HISTORIC PRESERVATION BOARD

HISTORIC PRESERVATION BOARD MEETING

PUBLIC HEARING
78 DANFORTH STREET

TO: Chair Sheridan and Members of the Historic Preservation Board
FROM: Rob Wiener, Preservation Compliance Coordinator
DATE: February 15, 2019
RE: February 20, 2019 **PUBLIC HEARING** – Site Alterations – Parking, Retaining Wall, Landscaping

Figure 2 Pedestrian Luminaire: Option 1 Acorn

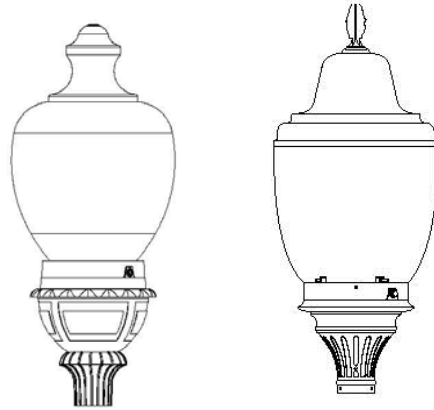
Staff request to replace the pedestrian light fixture as approved on 1.2.19 (Figure 1) with a luminaire type as represented by Option 1: Acorn (Figure 2) or Option 2: Cage (Figure 3) with the final fixture specification, manufacturer, and details to be selected by staff in conformance with the general characteristics represented in this report. If the Historic Preservation Board find the proposed light fixture to be appropriate for use within the historic landscapes as identified, the recommend pedestrian luminaire will be included in the proposed amendments to the *City of Portland Technical Manual Section 10 – Municipal Lighting Standards* as presented in this report.
